C Organizational Control of Emergencies

Table C-1 Minimum Staffing Requirements (STPEGS) (Including Capability for Additional Staffing)
Page 3 of 3

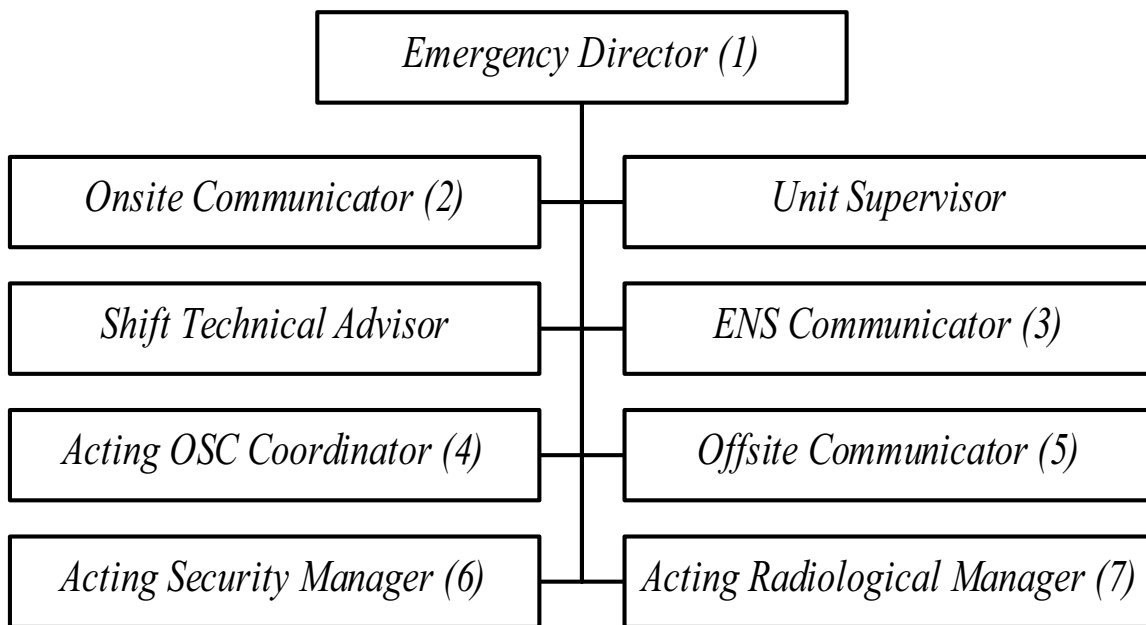
MAJOR FUNCTIONAL AREA	POSITION TITLE	UNIT 1/2 ONSHIFT* Per Unit	UNIT 3/4 ONSHIFT *Per Unit	ONSITE ONSHIFT	AVAILABLE 60 MINUTES #
<u>Rescue Operations and First Aid</u>	<u>Plant Protection Personnel</u>	=	=	2**	<u>Local Support</u>
<u>Site Access Control and Personnel Accountability</u>	<u>Plant Protection Personnel Security/Communications/ Personnel Accountability</u>	=	=	All per Security Plan	
	TOTAL	5/Unit	5/Unit	15	21
